## PHEASANT BRANCH GREENWAY ENHANCEMENT

CITY PROJECT NO. 14370

ADDENDUM #2  
REVISED THE FOLLOWING:  
SHEETS D1-D3  
SHEETS EC1-EC4  
SHEETS G13, G15, G112  
SHEETS P1-P19, P21, P24-27  
SHEETS U1-U18, U22  
SHEETS E1-E6  
SHEET PM1  
SHEETS X32A-X34, X45-X48

<b>GREENWAY EAST SIDE TRAIL</b>	<b>14370</b>	<b>P13</b>	14370 MADISON, WI CONTRACT NO: 9517	REVISION DATE BY Scale: AS SHOWN P13
Z:\Clients\City_of_Madison\Phaseant_Branch_Greenway_Enhancement\Engineering\Plan_Sheets\2023.0227_Sheet_Plan.dwg

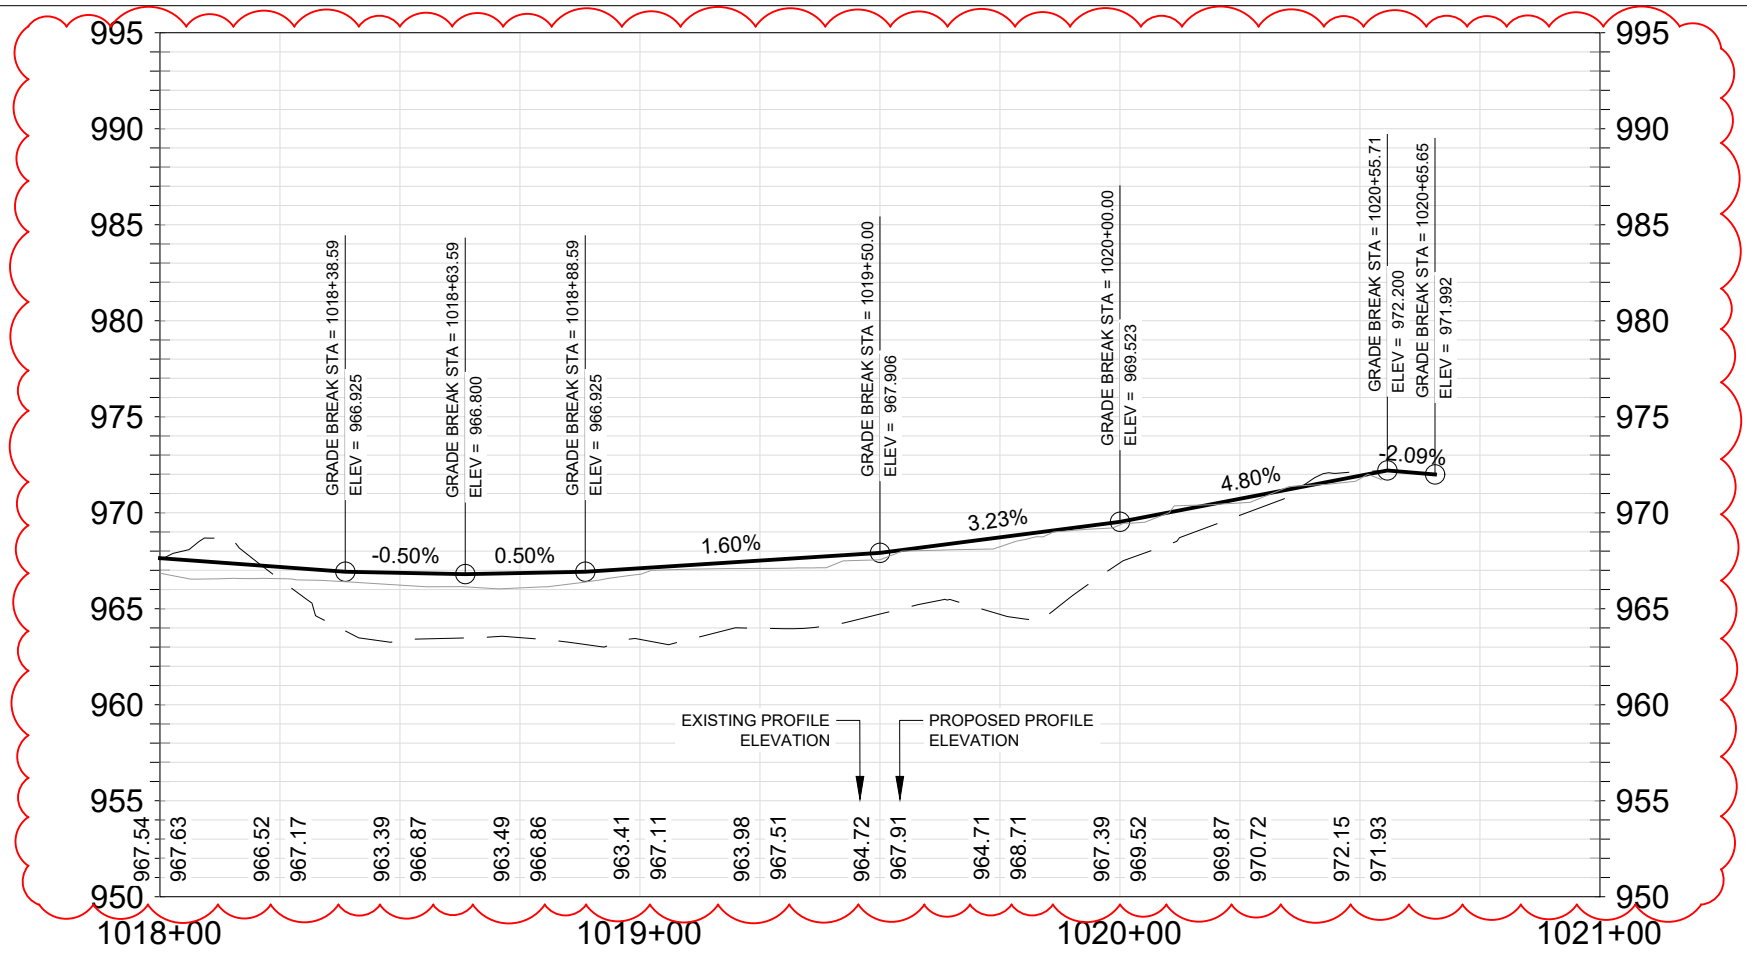
**ADDENDUM NOTE:**  
 -UPDATED LEGEND  
 -ADDED GRADE BREAK LABELS  
 -MODIFIED PROPOSED TRAIL PROFILE

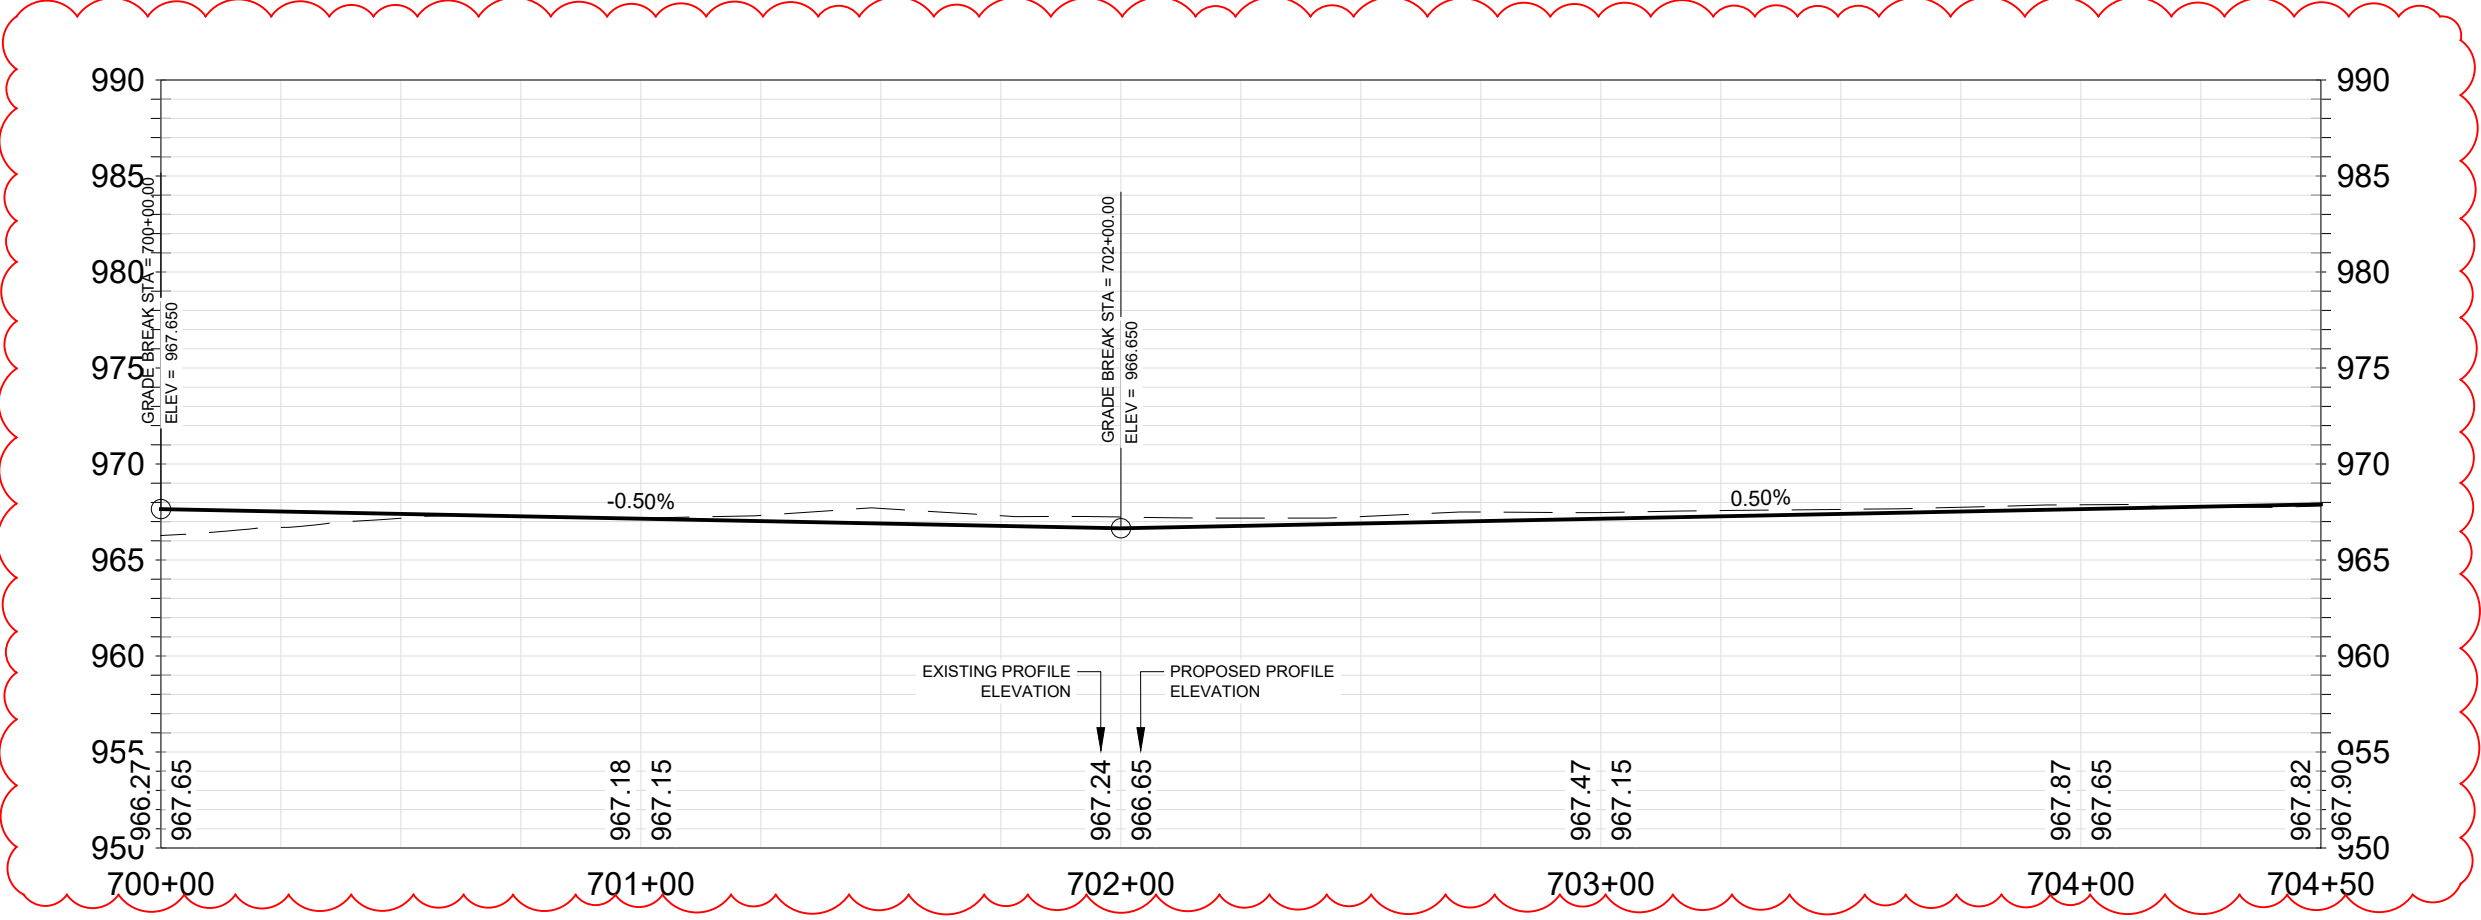
**ADDENDUM NOTE:**  
 -UPDATED LEGEND  
 -ADDED GRADE BREAK LABELS  
 -MODIFIED PROPOSED TRAIL PROFILE  
 -ADDED PRIVATE UTILITY NOTES

14370	REVISION	DATE	BY
14370	Designed By: JPC	Date: 11/06/2024 4:02 PM	Scale: AS SHOWN
14370	MARK		P15

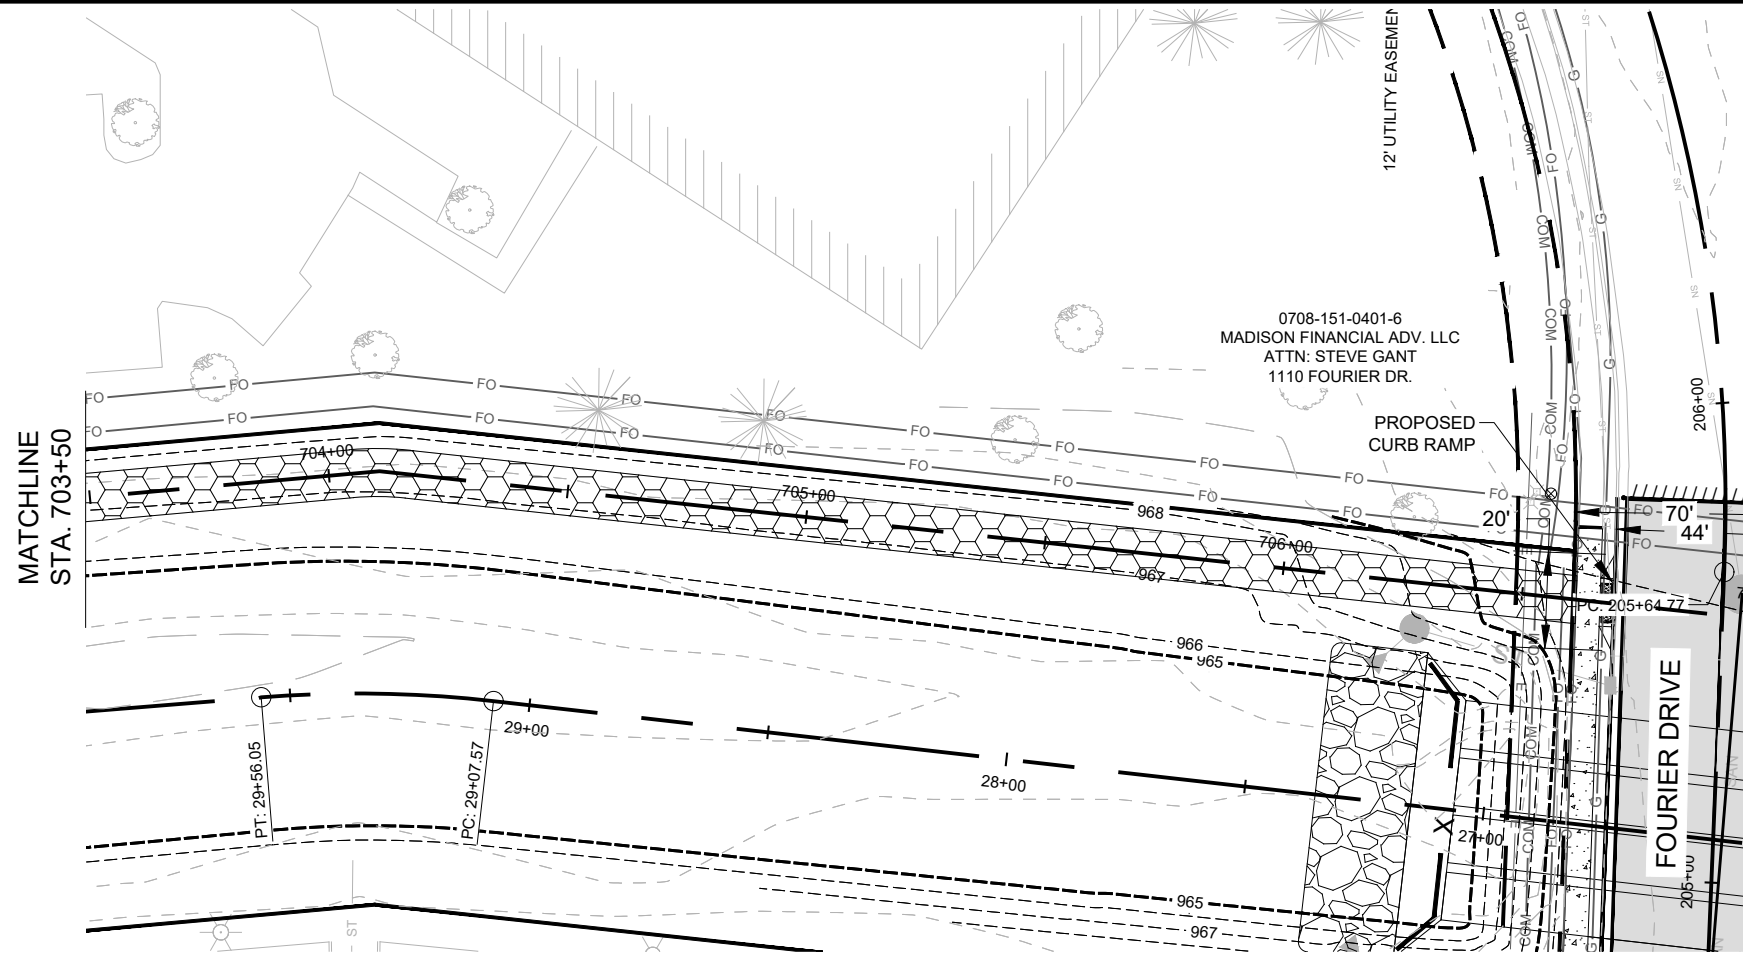
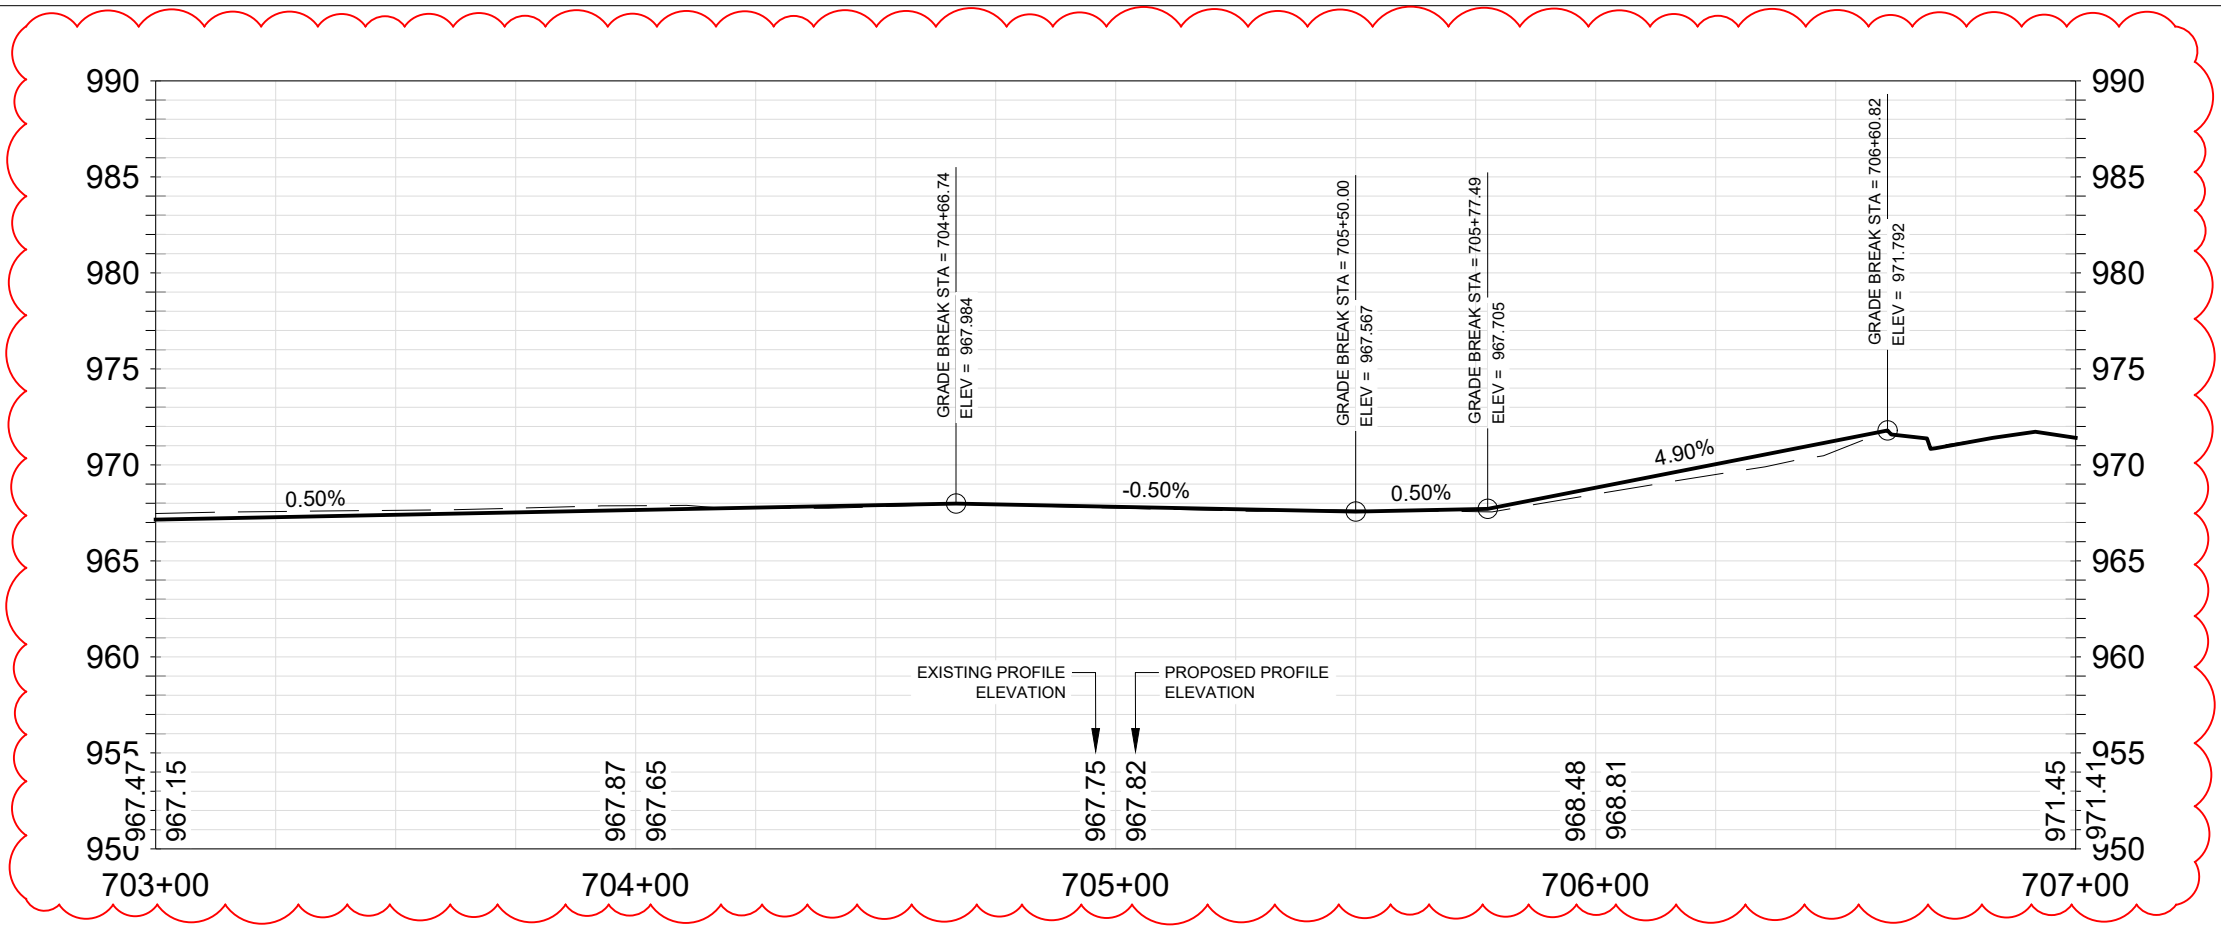
**ADDENDUM NOTE:**  
 -UPDATED LEGEND  
 -ADDED GRADE BREAK LABELS  
 -MODIFIED PROPOSED TRAIL PROFILE

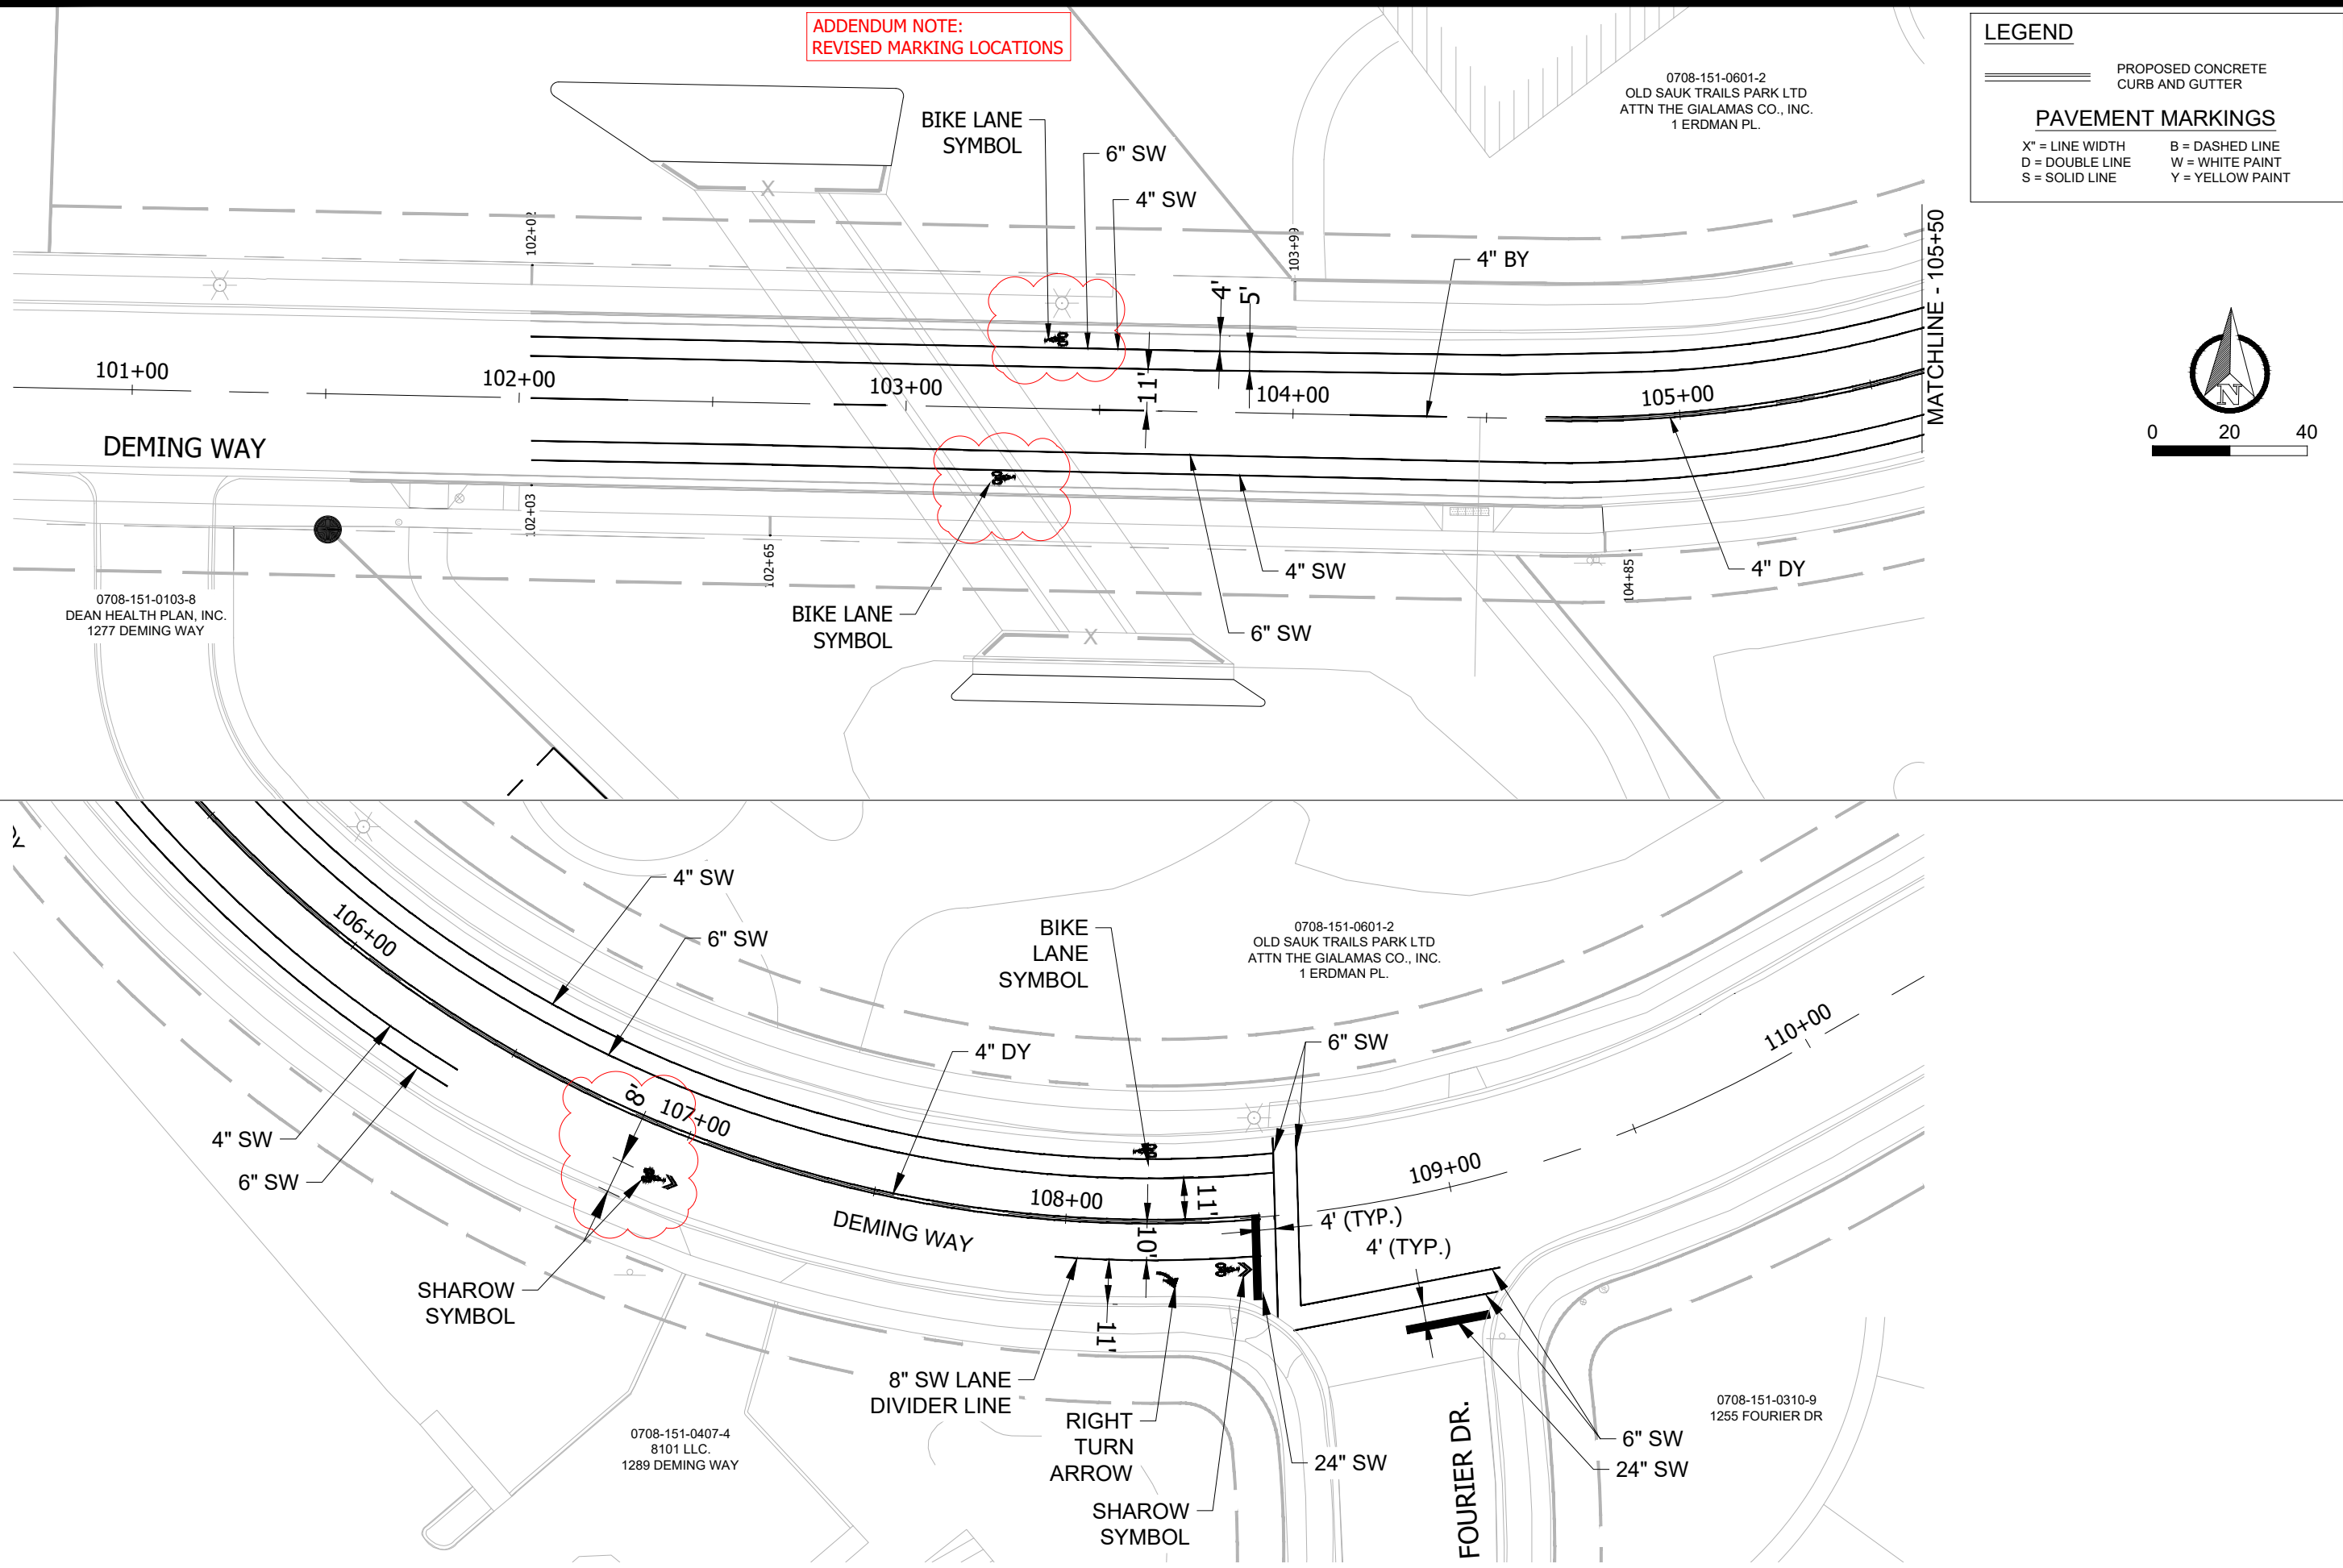
ADDENDUM NOTE:  
REVISED MARKING LOCATIONS
